New Auburn Village Center Redevelopment – Phase 1 Project

Project-Bid #2020-001 Due: September 5, 2:00 P.M.

Bid Addendum 1

EXISTING DRAINAGE AND SEWER STRUCTURES

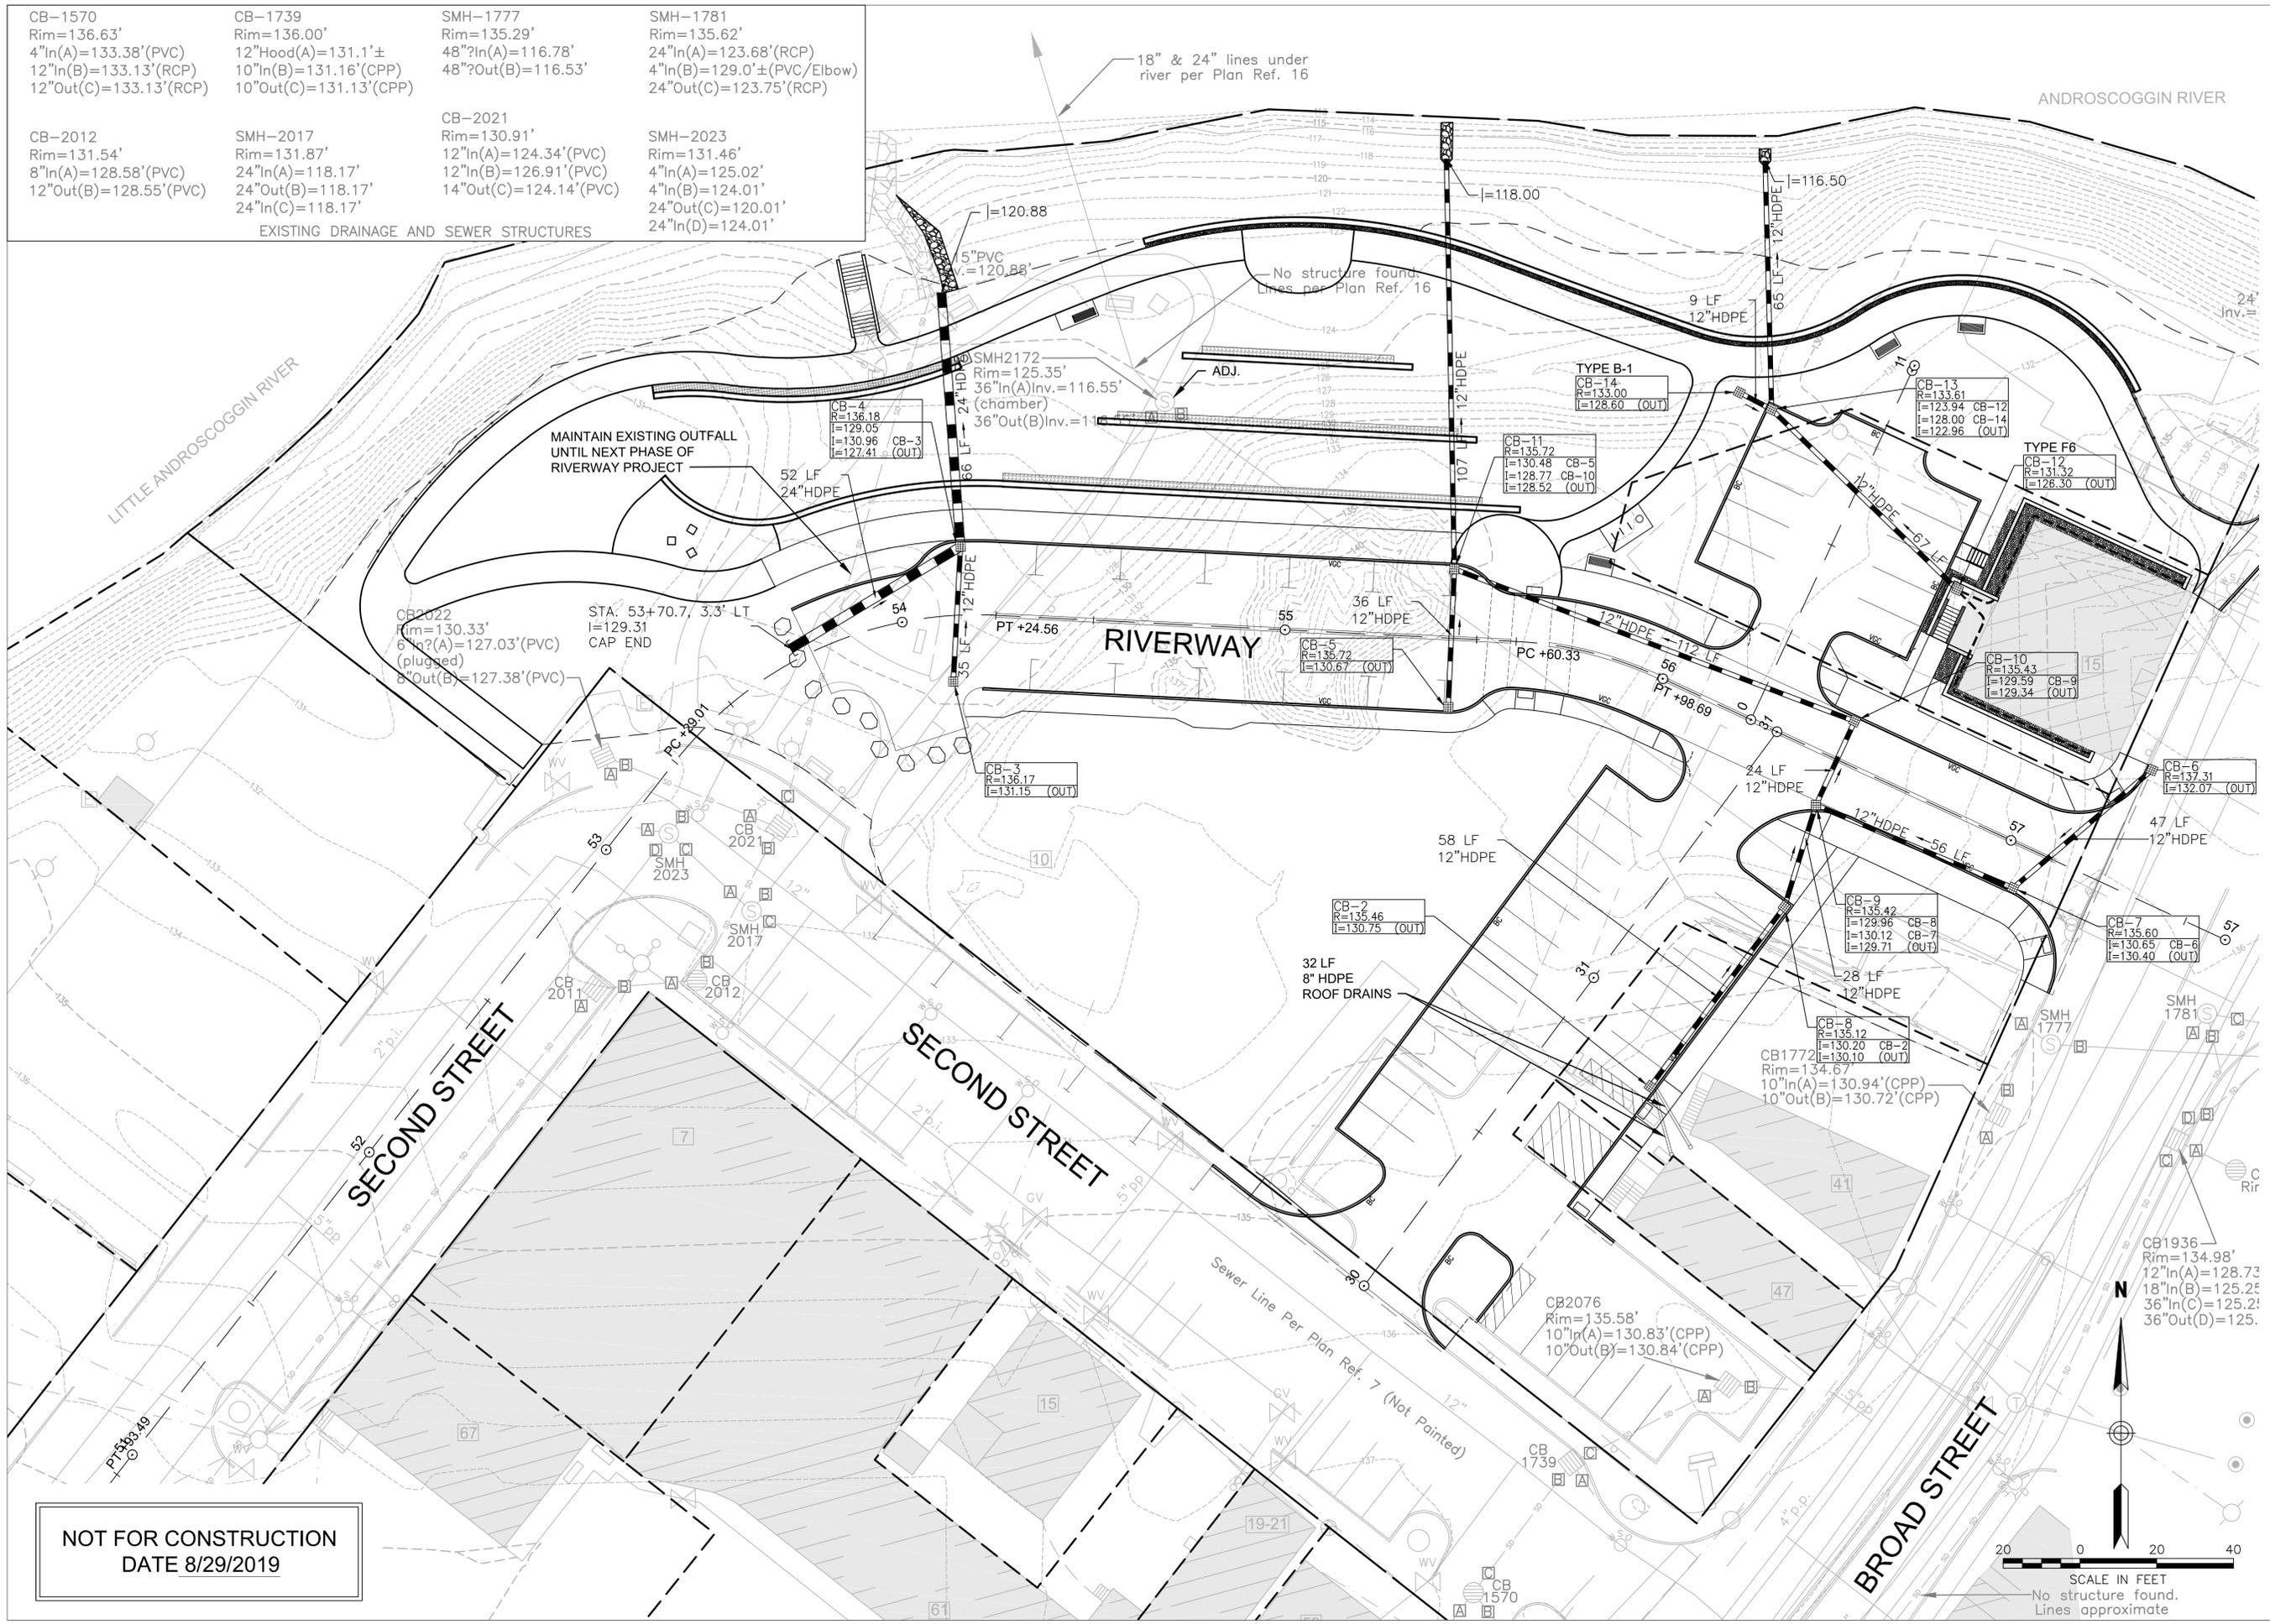
12. Question (by email): *Can you define the clearing limits on the plans? Sheet 19 also refers to notes that are not listed on the sheet.*

Answer: The clearing line has been added to the attached general plan. Note that grading and earth disturbance beyond the limits of grading shown shall not be permitted due to proximity to the river. It may be desirable to leave some tree stumps in place along the limits of work so stability of the bank is maintained. This should be coordinated with the resident engineer.
